Design Advisory Committee (February 19, 2025)

SMFA 4PLEX - ADDITION / RENOVATION

7229 Zimpel St.
New Orleans LA, 70118

Design Advisory Committee (March 19, 2025)

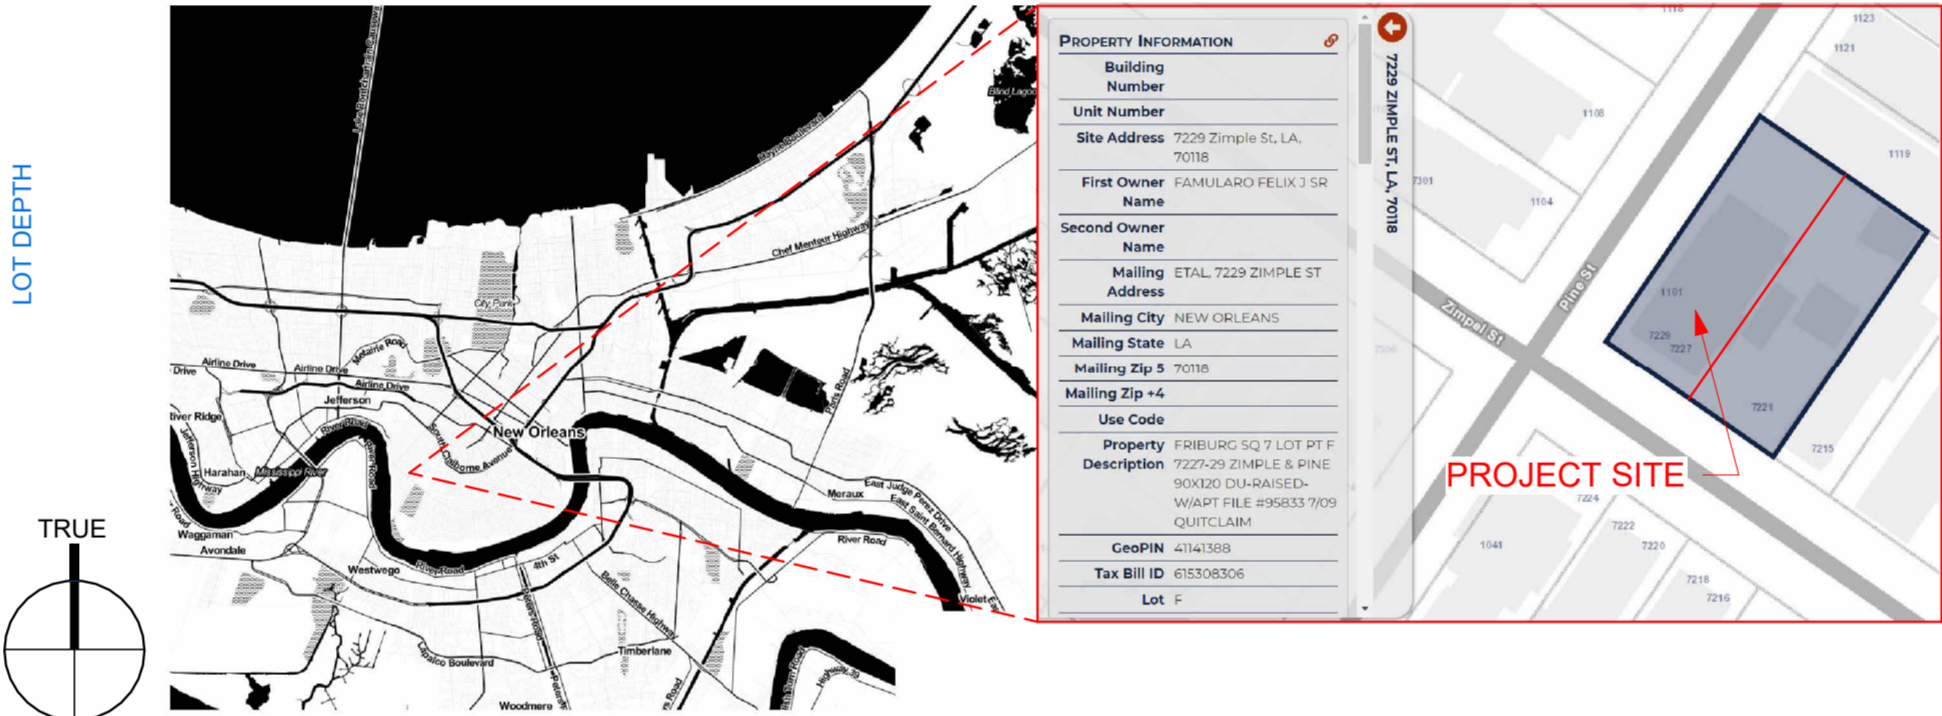
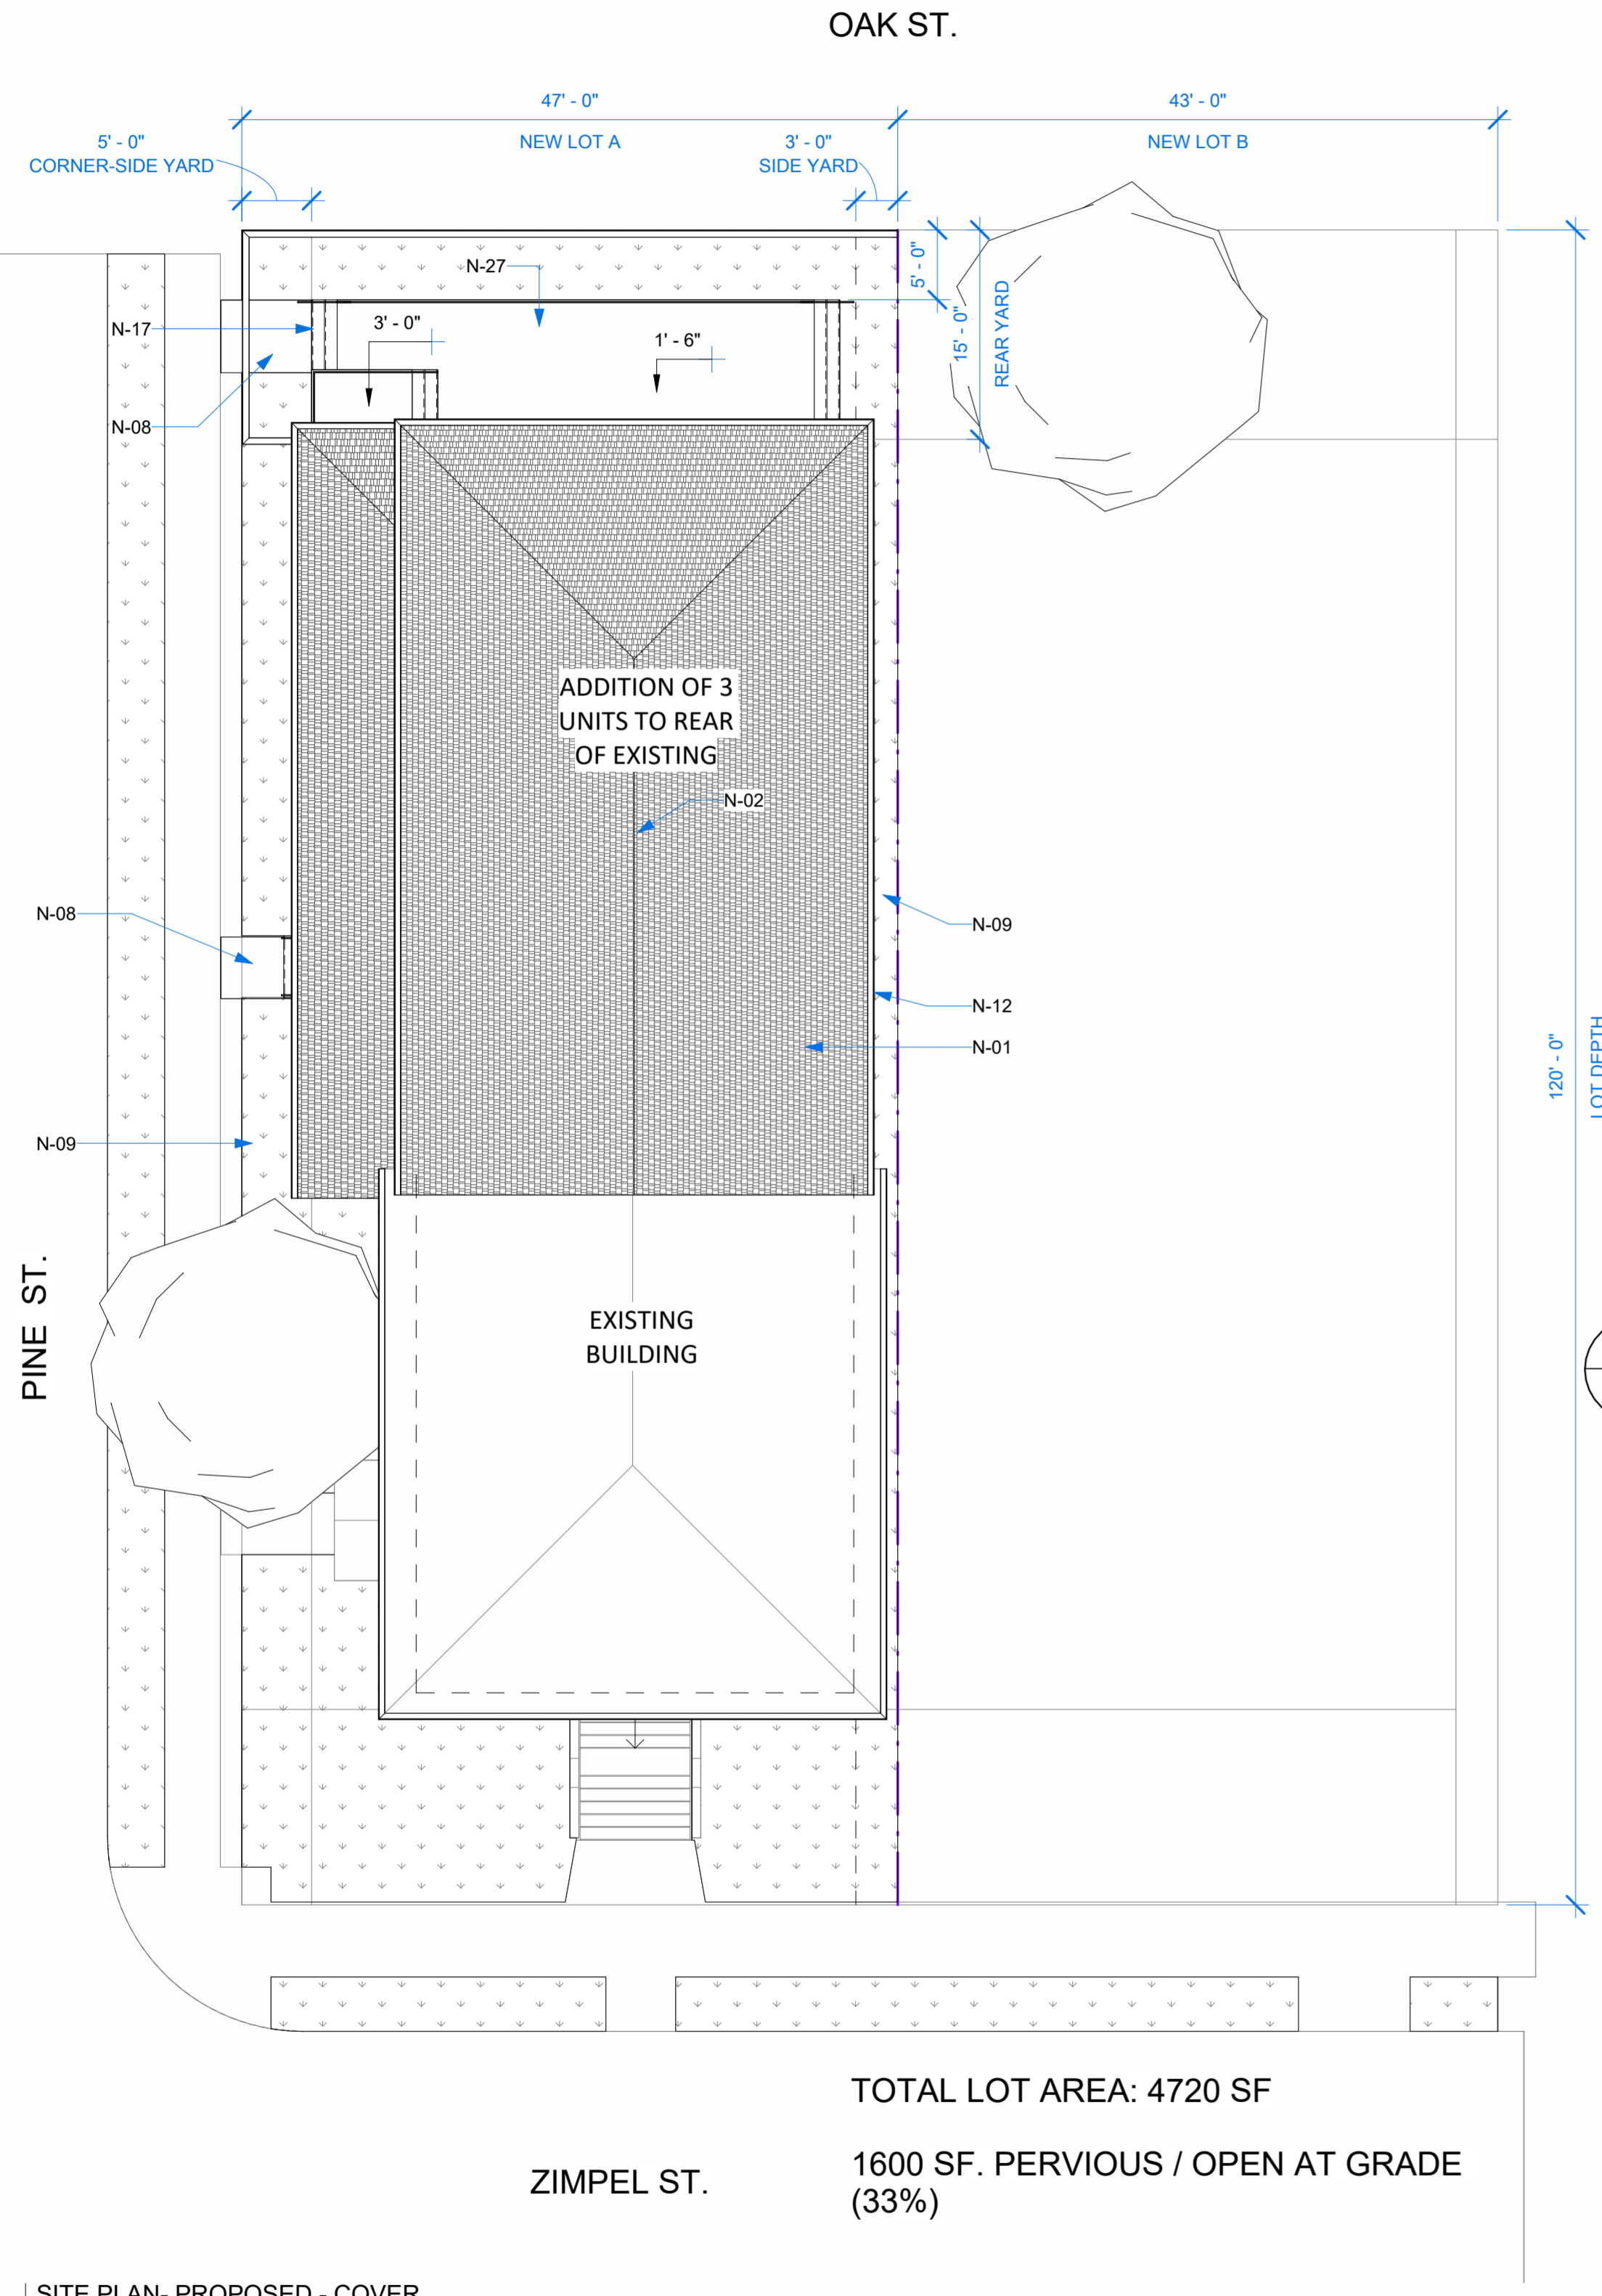
The applicant explains that a demolition of less than 50% of the building and would like to keep the existing frontage of the building. The HDLC representative states that the side addition to the property is problematic as it bumps out from the building and should be flush with the rest of existing structure.

The CPC representative asks HDLC what their thoughts are about the off-set heights of the building. HDLC responds that the applicant should try to maintain as much of the rhythm and pattern of what is existing.

The CPC representative states that that the concern that the proportion is off and needs to go all one direction to demo more than 50% or start the addition further back. Additionally, the offset of the windows from the front to the back of the structure compounds the design issue.

One constituent spoke in opposition to the item expressing concerns about the property not being used as affordable housing. The HDLC representative made a motion for DEFERRAL, seconded by the CPC representative, and unanimously adopted.

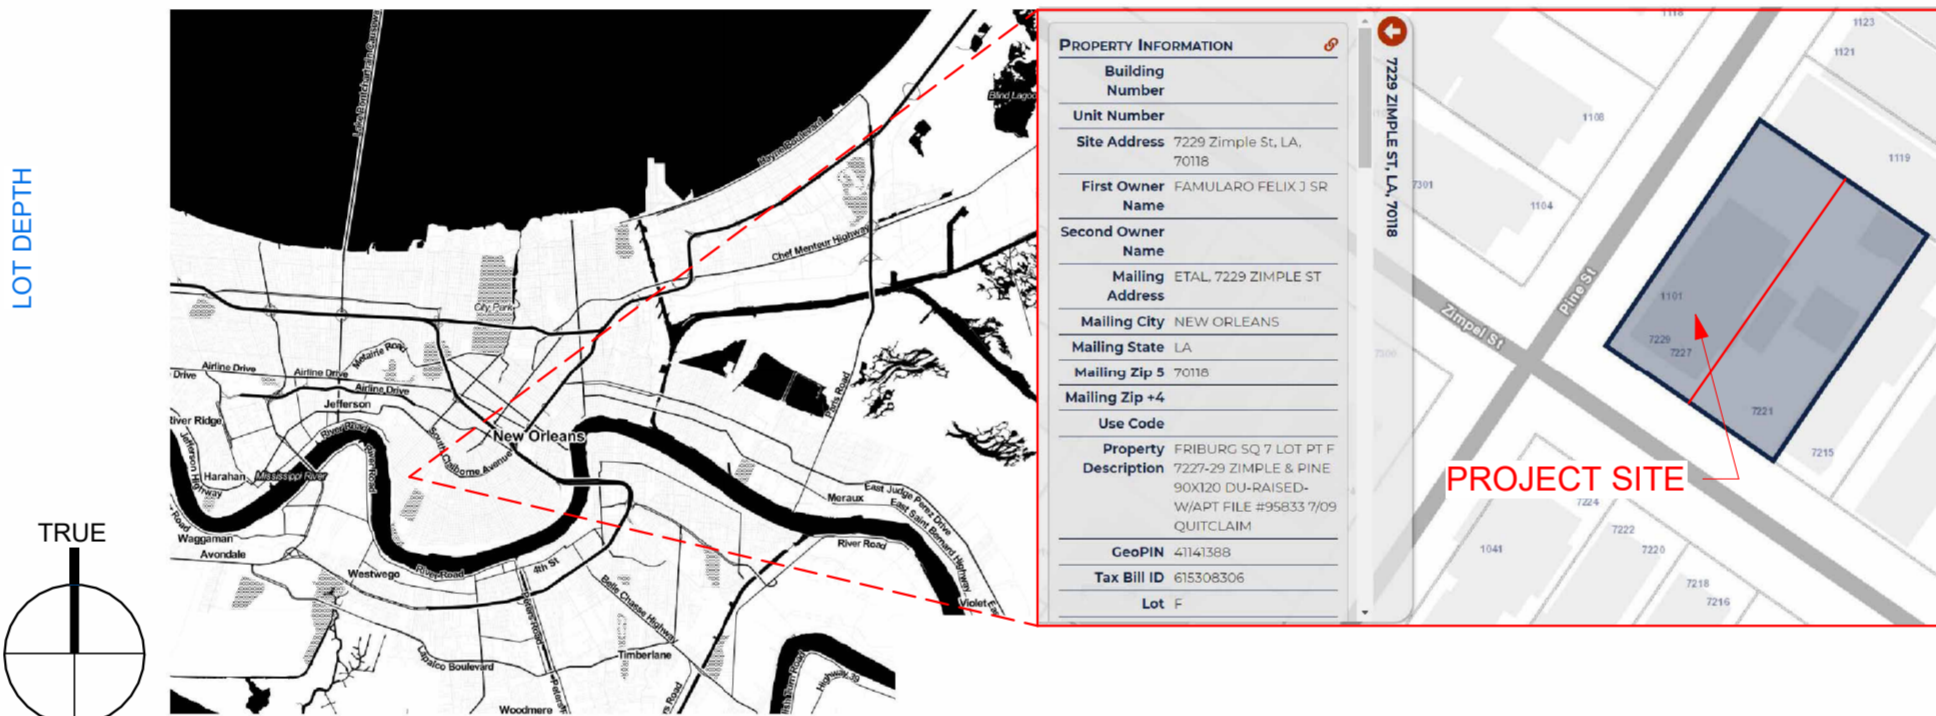
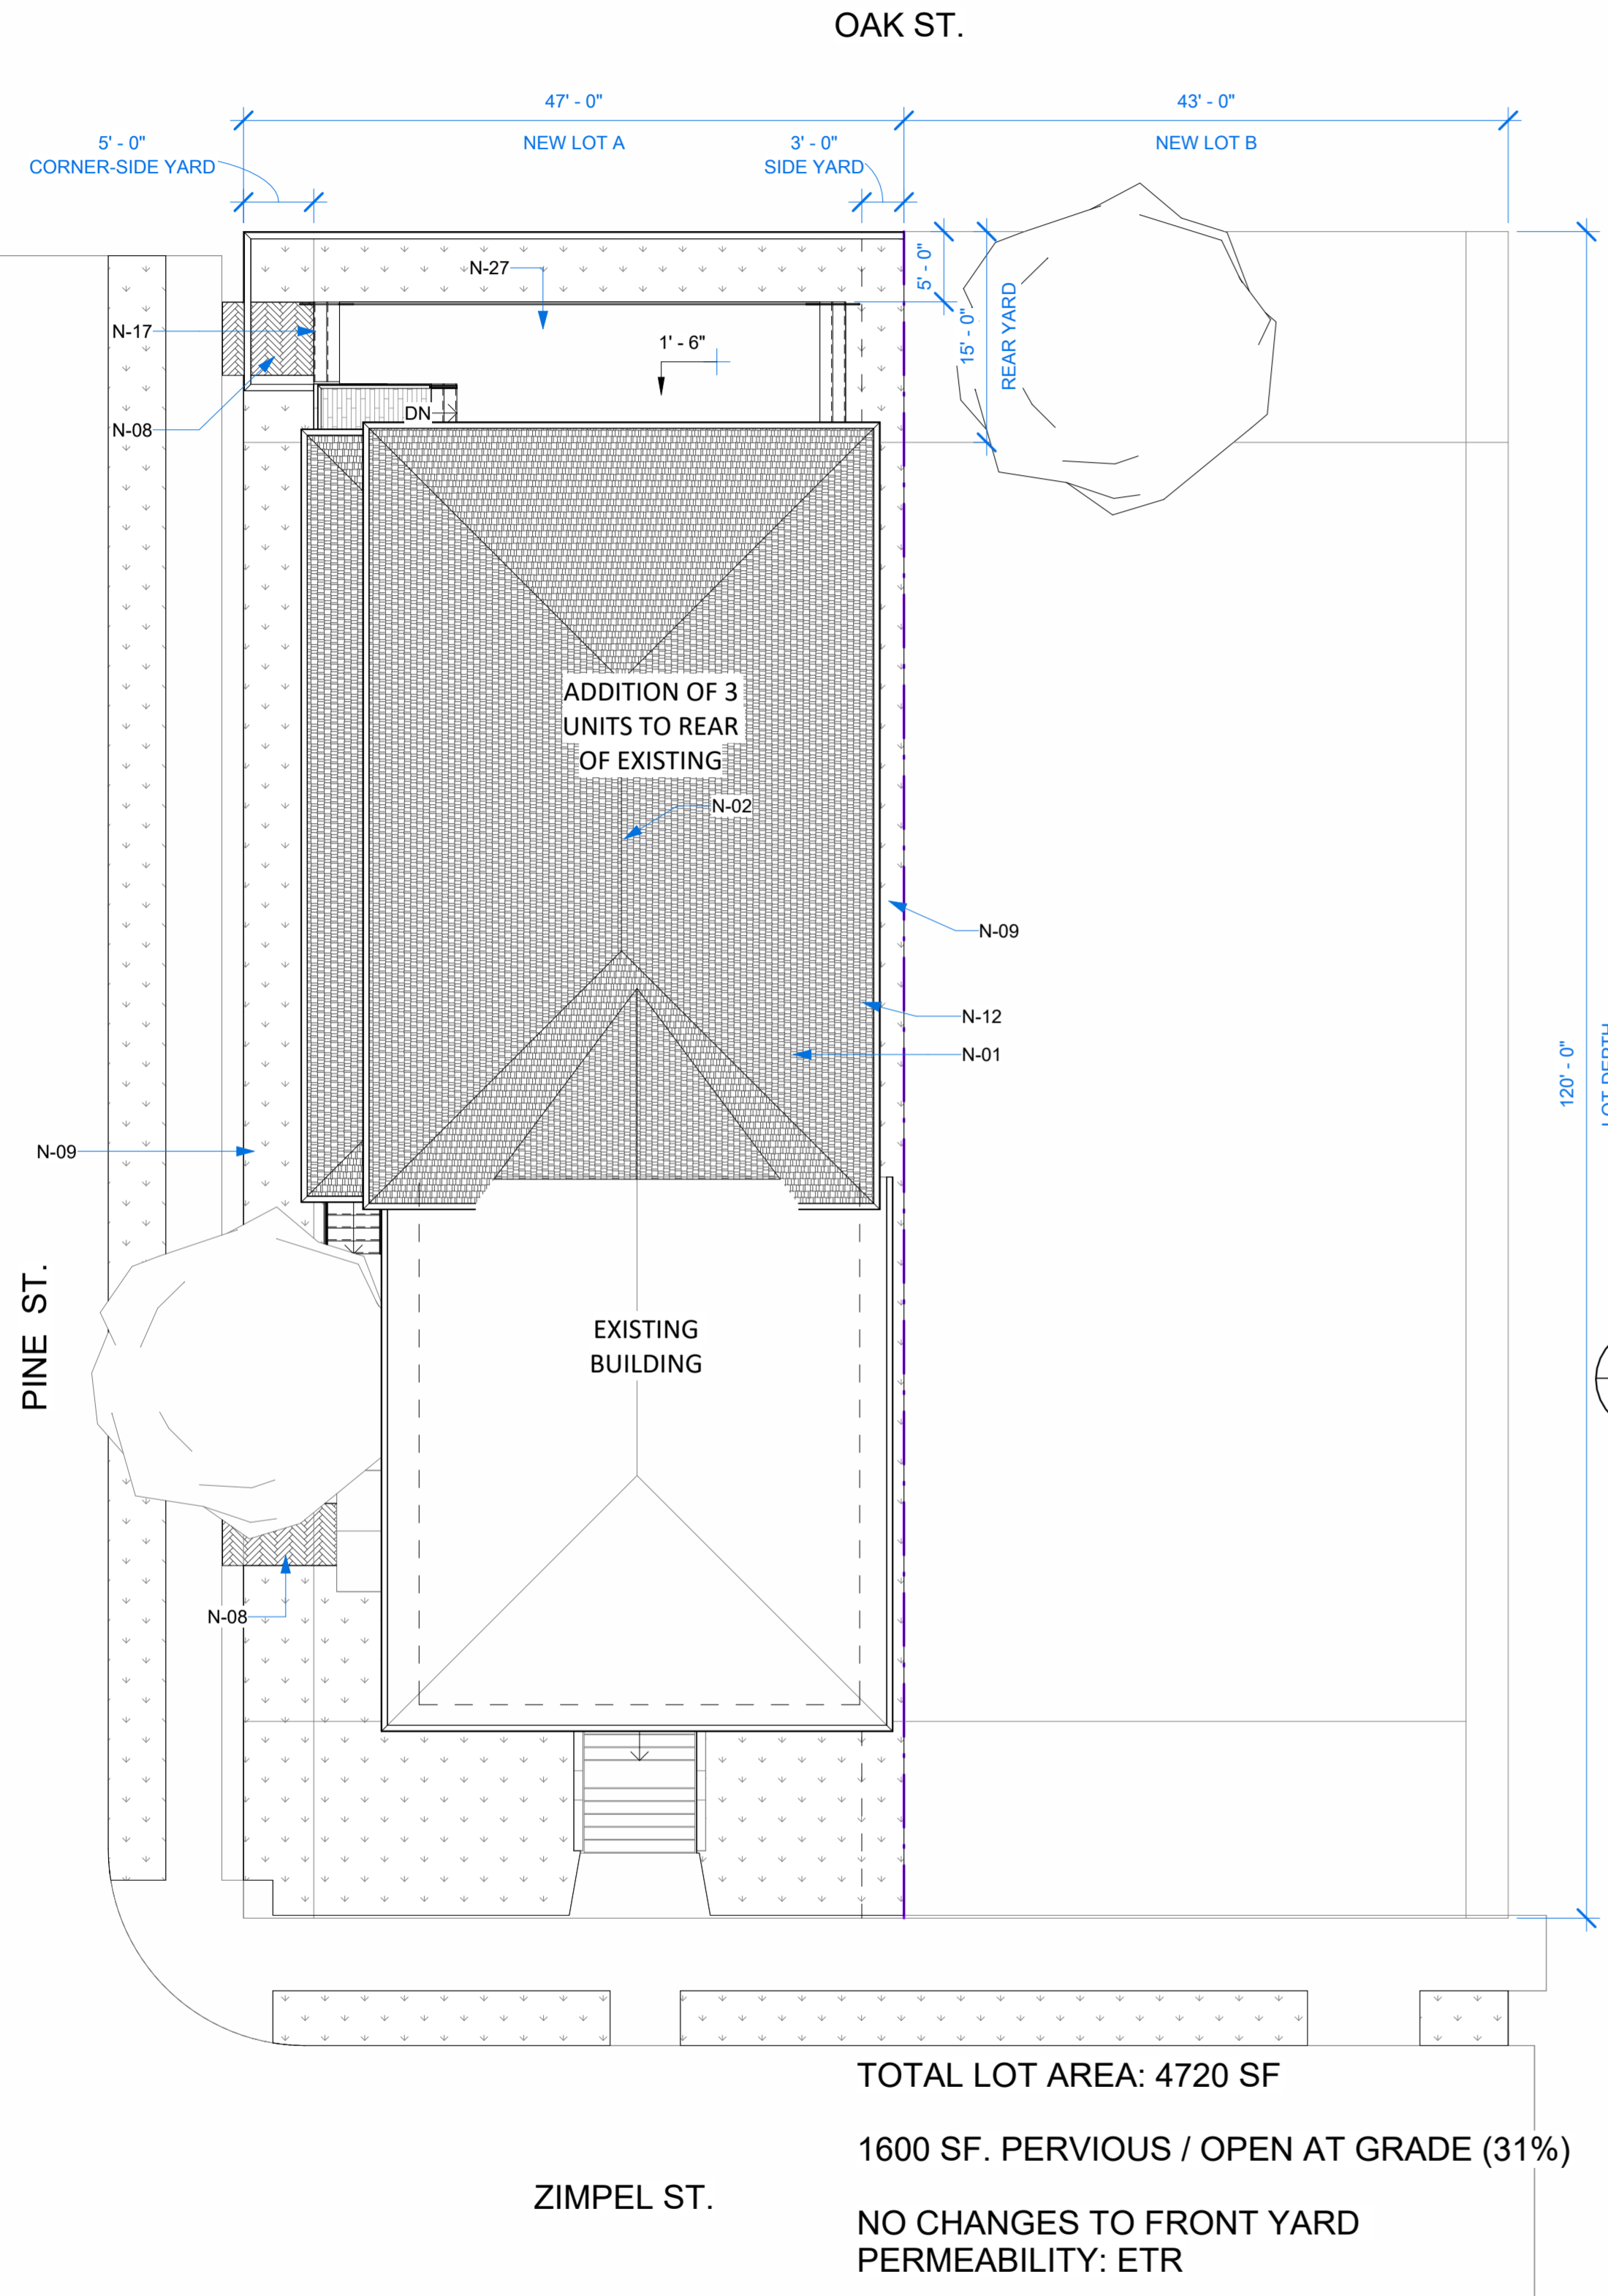
The HDLC representative took issue with the applicant's stated inability to make the addition flush. It was further stated that the changes to the side elevation are an improvement, however, it is still too large.

The CPC representative stated that they would not be supporting the proposed design as it is incompatible with the University Area Design overlay. They stated that the scale and massing is atypical relative to surrounding historic structures. The two-story addition is fundamentally incompatible with the existing structure, causing the misalignment of architectural features.

The applicant summarized the three modifications that were made: 1) removal of porch, 2) relocation of entry to the rear to read like a side elevation, and 3) shifting of addition back 3 feet. The applicant stated opposition to the suggestion that the addition be made flush with the existing building. There was one comment in opposition from Susan Johnson who relayed opposition from 17 neighbors and expressed concerns about affordable rentals, increased parking demand, and concerns about the addition of 24 bedrooms. The applicant rebutted addressing a commitment to meet affordable rental requirements.

The CPC representative made a motion for DENIAL, that was seconded by the HDLC representative and unanimously adopted.
